UNIVERSITY OF MARYLAND

United States Nuclear Regulatory Commission
One White Flint North MS 12G13
11555 Rockville Pike
Rockville, Maryland 20852-2738
ATTN: ALEXANDER ADAMS, JR

Enclosed please find the University of Maryland's response to the request for additional information as it pertains to sections six through ten of the Safety Analysis Report (SAR).

REQUEST FOR ADDITIONAL INFORMATION
UNIVERSITY OF MARYLAND RESEARCH REACTOR
DOCKET NO. 50-166

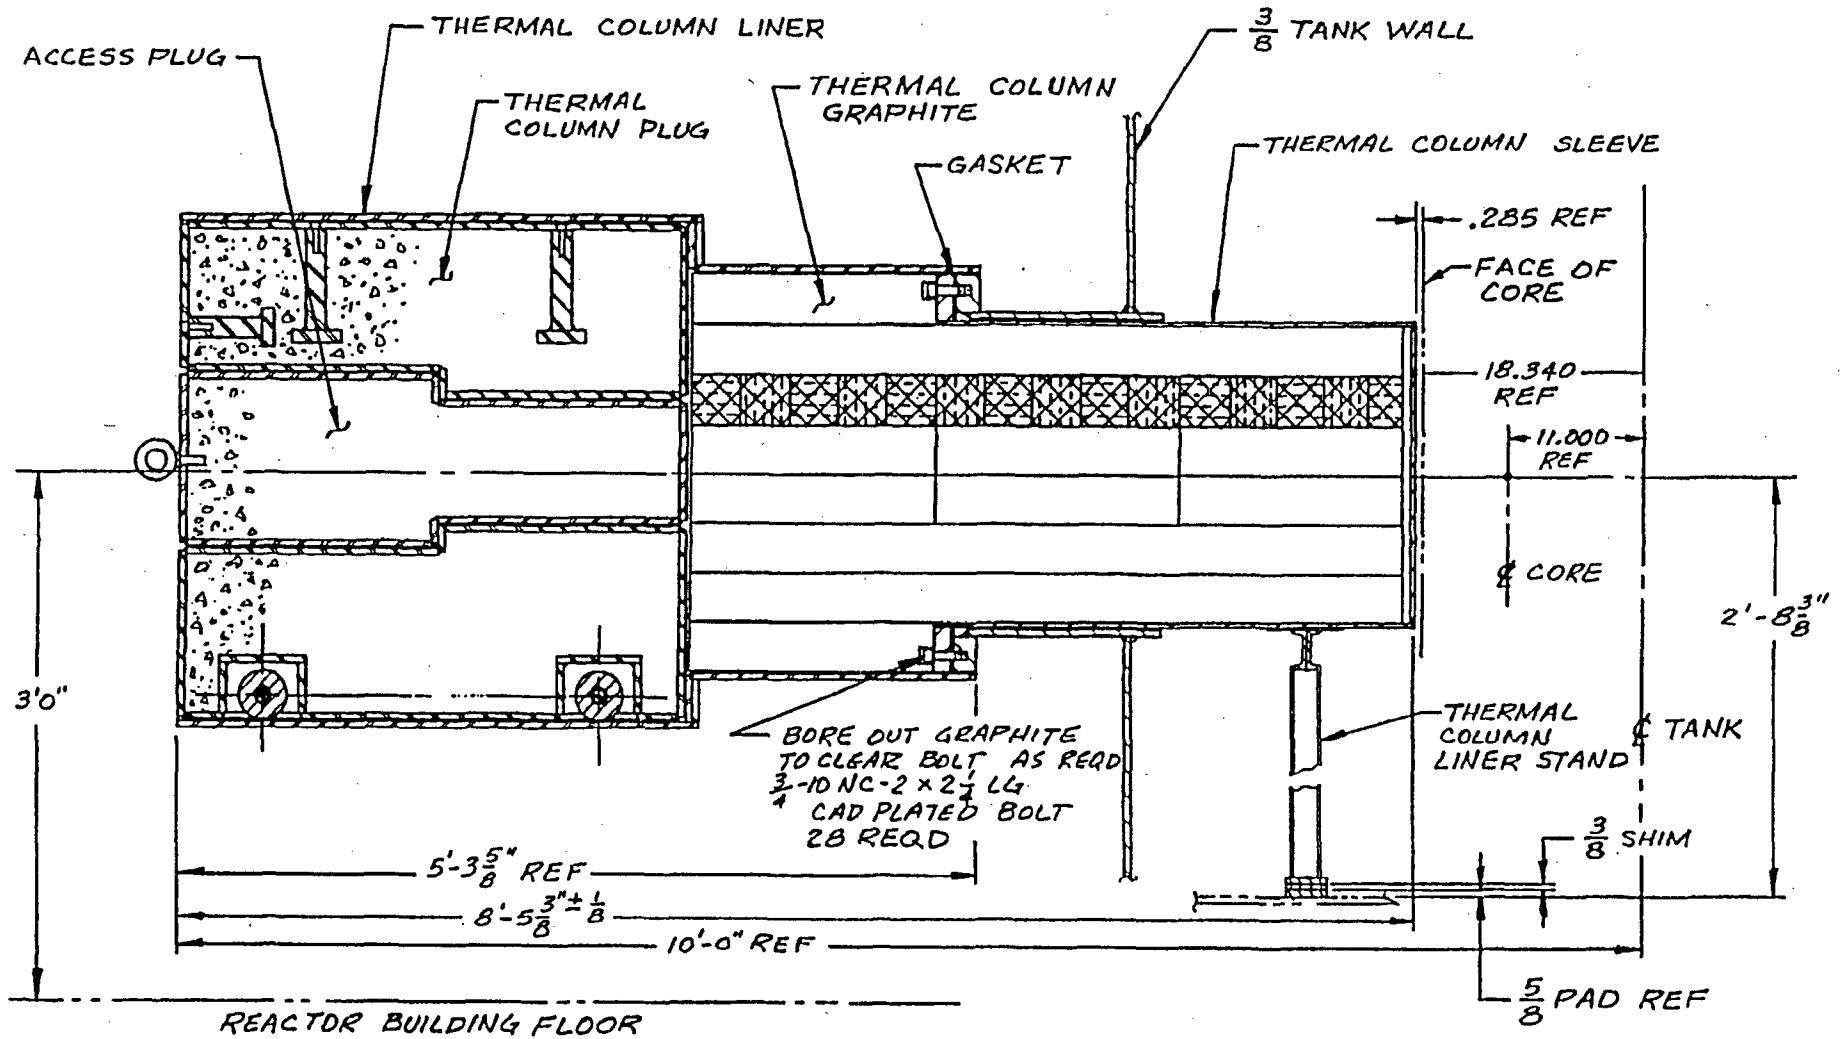
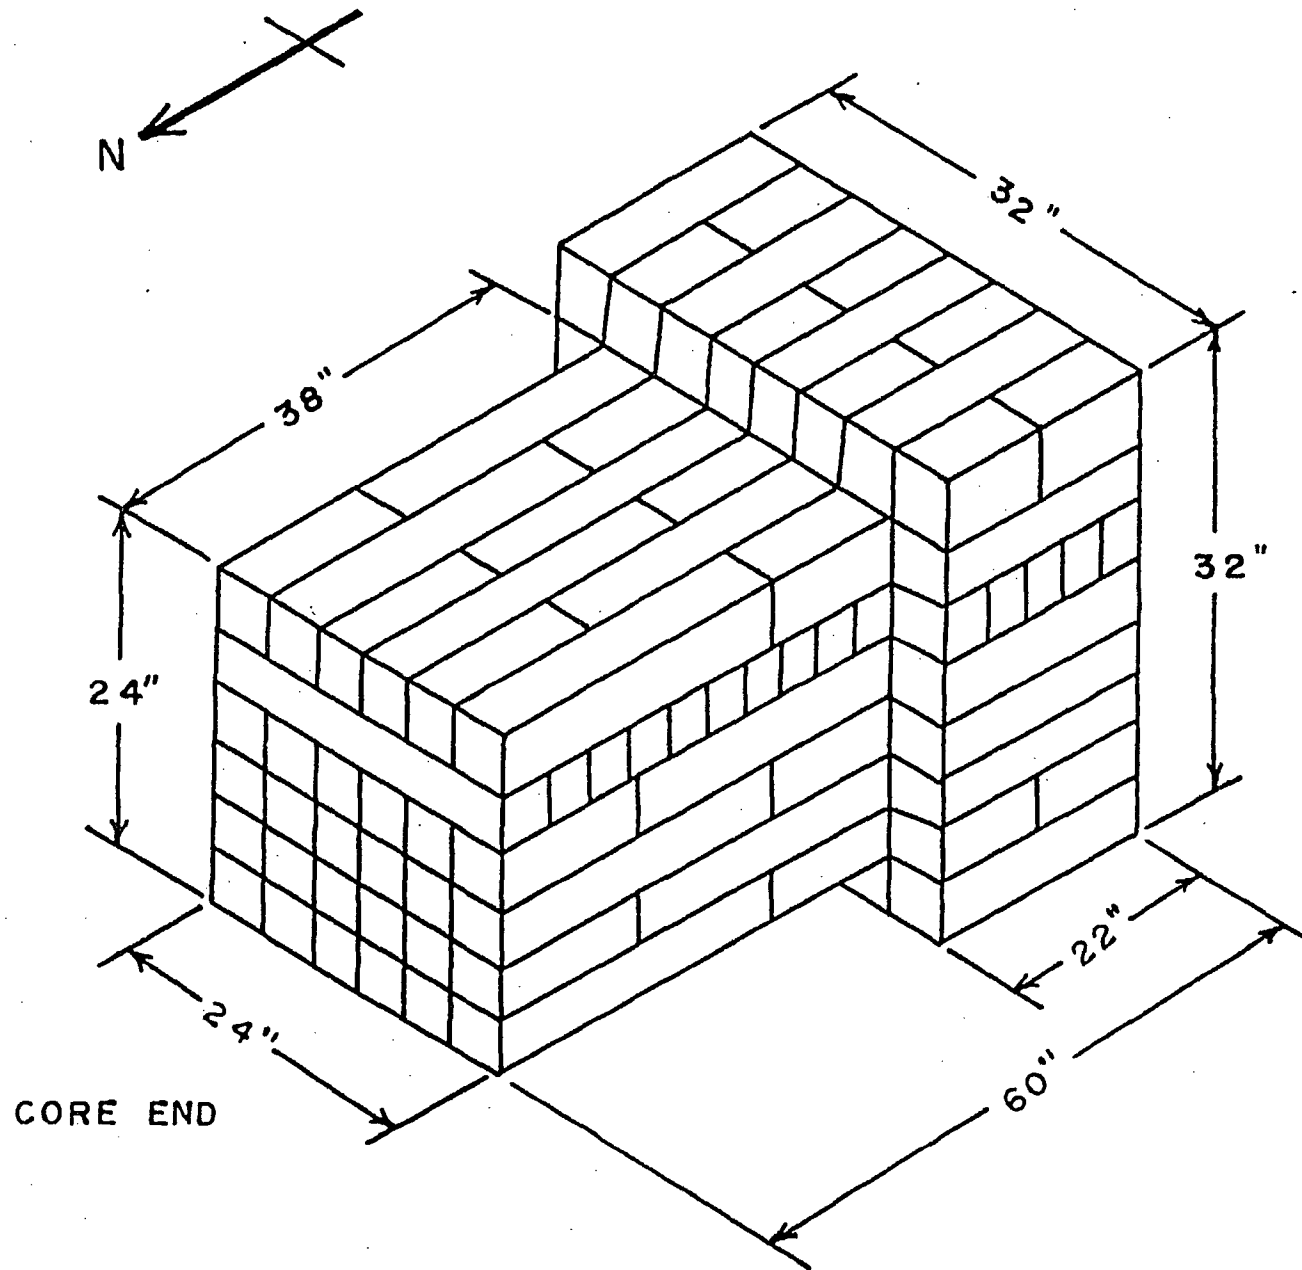
38. Section 10.2, Experimental Facilities. Provide a more detailed description of the functional design of the Thermal Column, Beam Ports and Through Tube experimental facilities. For example, from the description provided it is not clear if these facilities require an air exhaust system or if beam tubes must be filled with demineralized water to provide shielding. Additionally, Figures 10.3, "Beam Tube," 10.4, "Beam Tube Plugs," and 10.5, "Through Tube" are not legible (apparently due to their reduced size). Please provide clearer illustrations that are of a larger size. Enlarging each figure to 8½ by 11 inches should be sufficient.

See Attached

INNER PLUG
4 REQUIRED
WEIGHT - 132 LB APPROX

1. FILL BOTH PLUMS WITH ORDINARY CONCRETE (184 LB / CU FT APPROX)
2. MACHINE AFTER FILLING WITH CONCRETE.
3. APPLY MORTAR COAT AFTER MACHINING
